U. S. NUCLEAR REGULATORY COMMISSION
OFFICE OF INSPECTION AND ENFORCEMENT

Report No. 50-458/80-03

Facility Name: River Bend Station, Unit No. 1

Investigation Summary:

FIGURE (1)

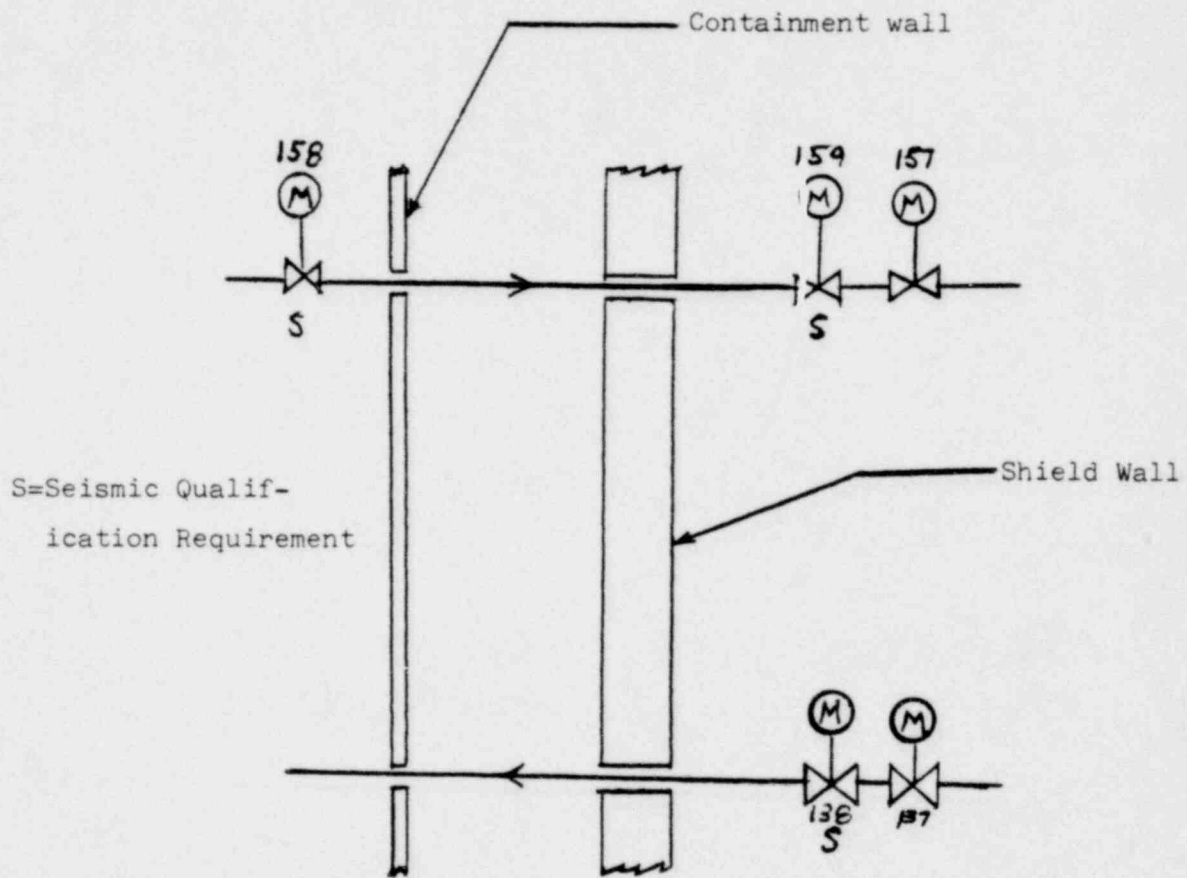
A Component Cooling Water isolation valve is not seismically qualified.

The IE inspector reviewed Stone & Webster Construction Specification 228.212-047-4 (Addendum No. 2, 3/9/76), "Motor Operated Carbon Steel Valves," which is made part of the procurement document package. Stone and Webster print 2210-FSK-9-1G, "Reactor Plant Component Cooling Water," was also reviewed. This print identifies five motor operated valves: MOV 137, MOV 138, MOV 157, MOV 158 and MOV 159. (See Figure 1 for a sketch of the system for valve location.) The specification (Appendix A) identifies MOV 158, MOV 159 and MOV 138 as requiring seismic qualification. The PSAR, Table 7.3.1-5 identifies Criterion 57 of Appendix A (10 CFR 50) as applicable to this type of motor operated valve.

The IE inspector determined that the system isolation valves MOV 138, MOV 158 and MOV 159 are being manufactured by Velan and have not been delivered to the site. These valves have received a design review in accordance with ASME, Section III and a functional qualification test to meet the requirements of Regulatory Guide 1.48, "Design Limits and Loading Combinations for Seismic Category I Fluid System Components."

Based on the above information, the IE inspector concluded that the seismic requirements for Reactor Plant Component Cooling Water isolation valves have been established, and that sufficient controls exist to ensure that the valves are designed, manufactured and will be delivered to meet regulatory seismic requirements. This allegation could not be substantiated.
